CITY OF UNALASKA
Aquatics Center Improvements
Project No. 15101

ADDENDUM TO THE CONTRACT

Addendum No:	4	Current Bid Opening Date: February 3, 2016 at 2:00 P.M.
Pages This Addendum:	8	
Attachments This Addendum:	1, 2, 3, 4, 5, 6, 7, 8, 9	
Previous Addenda:	Three	Previous Bid Opening Date: January 29, 2016 at 2:00 P.M.

Addendum Issue Date: January 28, 2016

DRAWN BY:	JOB NO.:	SHEET CONTENTS:
GW	1502	STARTING BLOCK
CHECKED:	DATE:	DRAWING NO.:
GW	1/12/2015	SKA-1

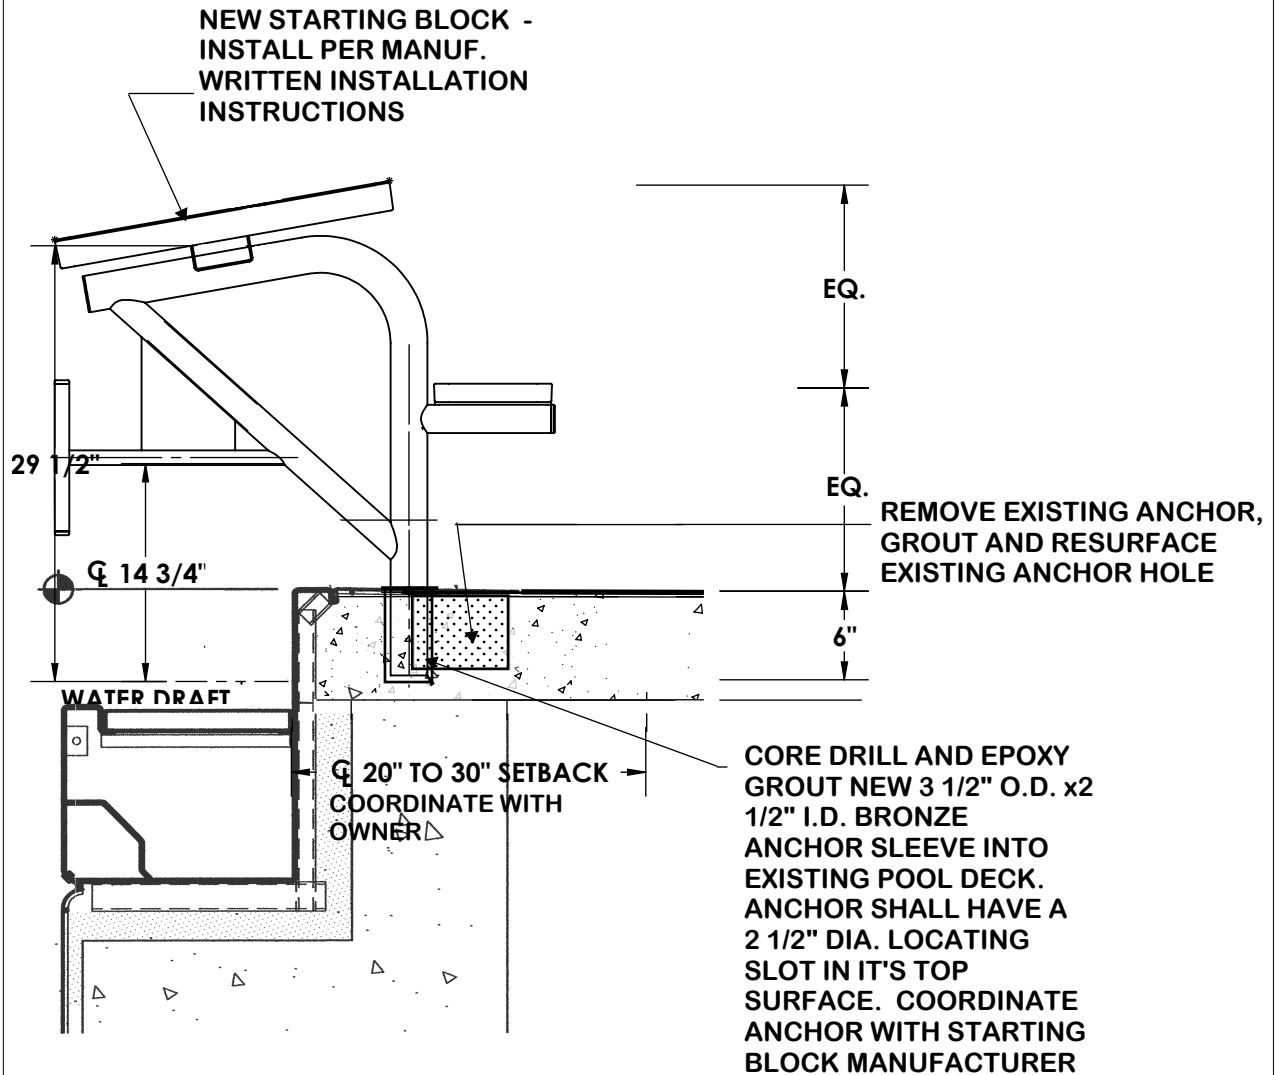
Response 16: The starting blocks are a stand-alone product specified as a basis of design and noted/specified on Sheet A2.1 (Sheet Note 7). The work to remove the existing starting blocks, install the new starting blocks and patch the existing deck is part of the base bid work. (See reissued Sheet A2.1)

The existing 6 starting blocks are to be removed and 6 new starting blocks are to be reinstalled per detail SKA-1 (reissued 1/22/2016). (See attached drawing SKA-1 and Starting Block Data Sheet)

THIS DETAIL DESCRIBES THE INSTALLATION OF NEW STARTING BLOCKS (6 TOTAL). REMOVE EXISTING STARTING BLOCKS AND ANCHORS, FILL DECK WITH EPOXY GROUT AND RESURFACE

Sheet Contents
RENO PLAN
FIRST FLOOR EAST

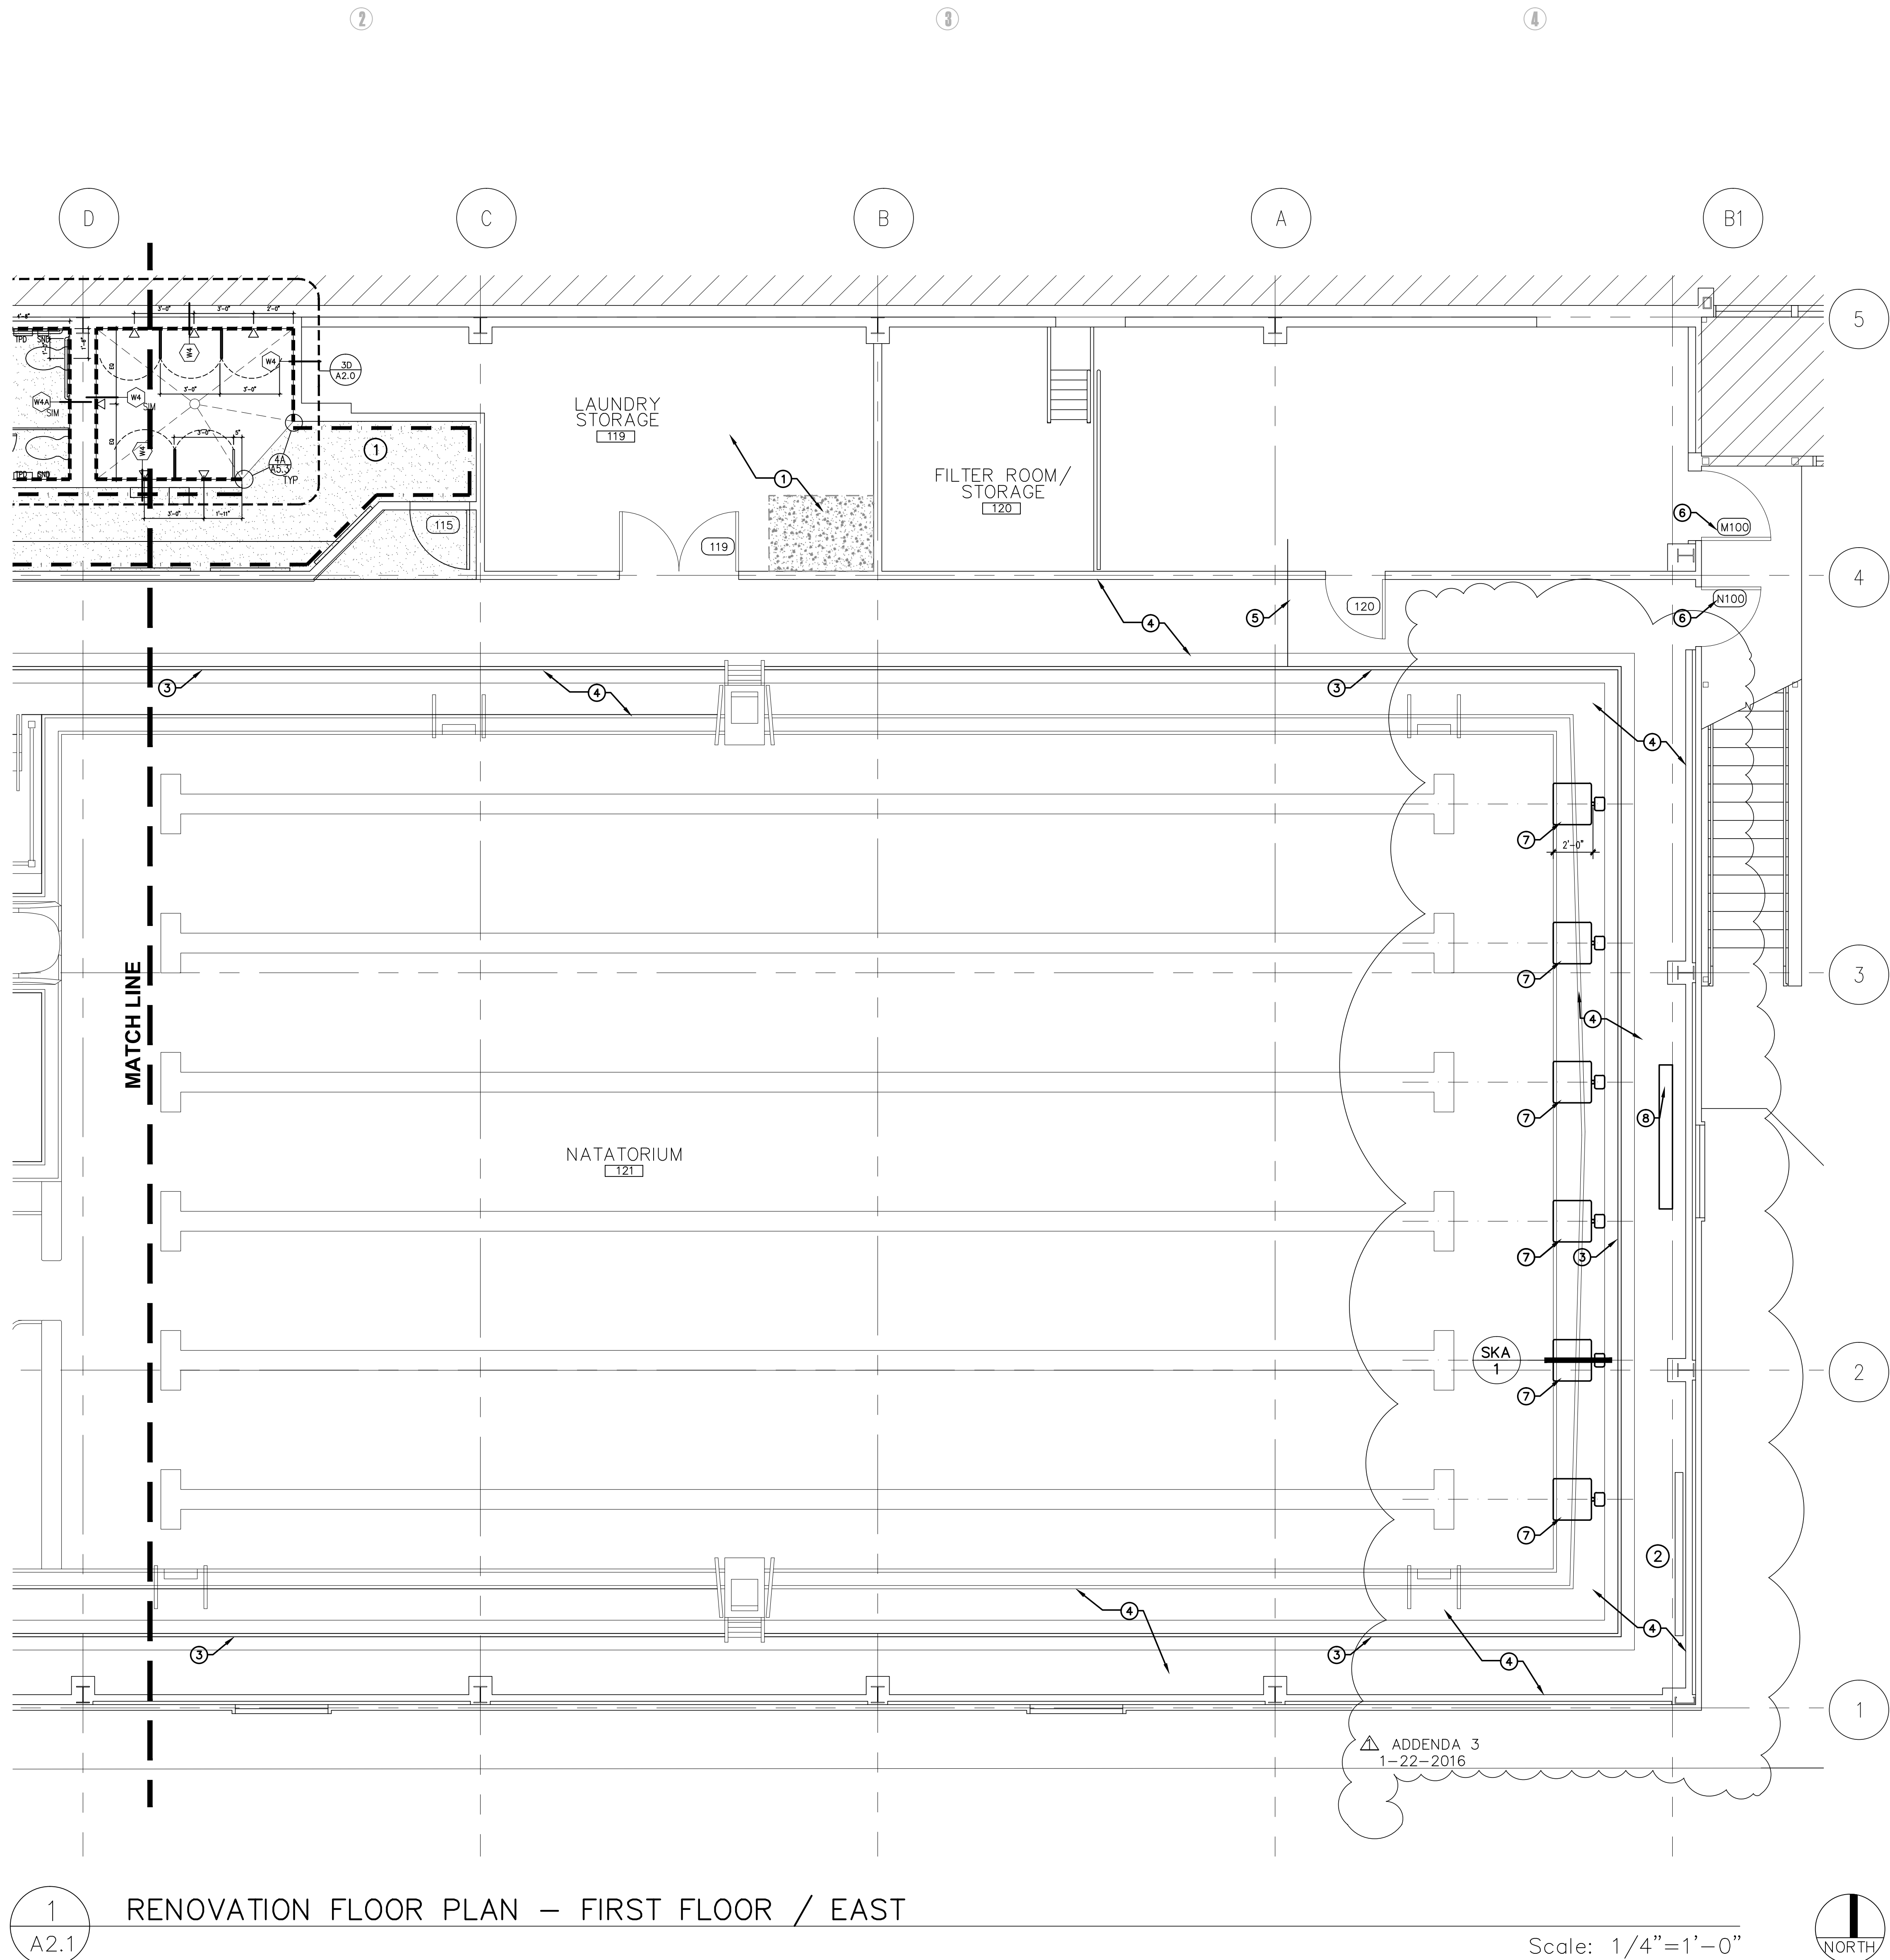
Response 19: See attached reissued Sheet A2.1 as well as, Addenda 2, Attachment 2E, and attachment E31-SKE-1 for the correct Location. Reference Sheet E3.1; *Relocate power and signal connections to location of new scoreboard* - Remove quad power receptacle and PVC junction box at south east corner of pool and install two new weather resistant GFCI type duplex receptacles and a 2x4 PVC junction box for new scoreboard. Reconnect power outlets to the power branch circuitry made available from the removal of the quad receptacle. Extend 1" PVC conduit from the new 2x4 PVC junction box to the existing 1" PVC intended for the scoreboard controls. See attached sketch for approximate locations and requirements. See attached electrical drawings SKE-1 – E3.1

- APPROXIMATE LOCATION OF EXISTING UNDERSLAB TRENCH DRAIN CONNECTION
- ALT. 1 DOOR HARDWARE - SEE DOOR SCHEDULE
- CORE NEW HOLE IN POOL DECK AND INSTALL NEW STARTING BLOCKS, STARTING BLOCKS TO BE SIM. AND EQUAL TO SPECTRUM GRIZZLEY STARTING BLOCK. HOPE 23"X25" - INSTALL PER MANUFACTURER'S WRITTEN INSTALLATION INSTRUCTIONS (6 TOTAL) CENTER ON SWIM LANE. CONFIRM FINAL POSITION WITH OWNER PRIOR TO CORE DRILLING HOLES

- LOCATION OF NEW WALL MOUNTED TIMING SYSTEM. SUPPORTS TO BE DESIGN/BUILD BY CONTRACTOR - SUBMIT ENGINEERING CALCULATIONS FOR REVIEW - TOP OF TIMING BOX TO BE APPROXIMATELY 14' A.F.F.
